Access Compliance Report Public Rights-of-Way (Curb Ramps)

Main Street: FALABELLA_DR Cross Street: FALABELLA_DR Location: N

ADA ID: RPRK211202120041 Ramp Type: Type 1 - Perpendicular Initial Pass/Fail: Fail Overall Compliance: No Severity Score: 2

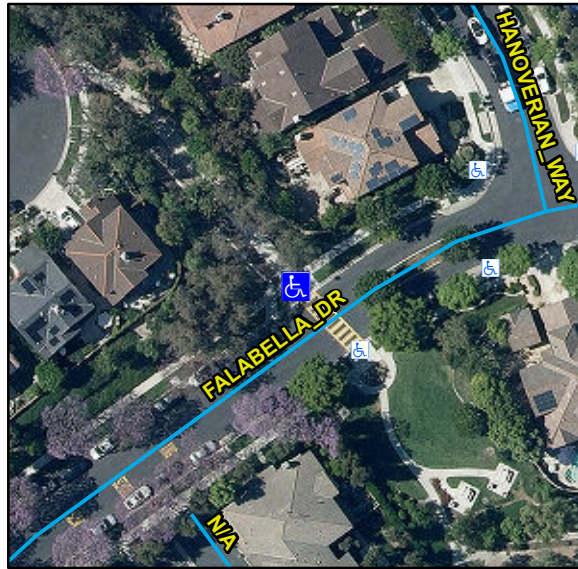
R304.5.3, STD 1115

Remove & Replace Entire Ramp.
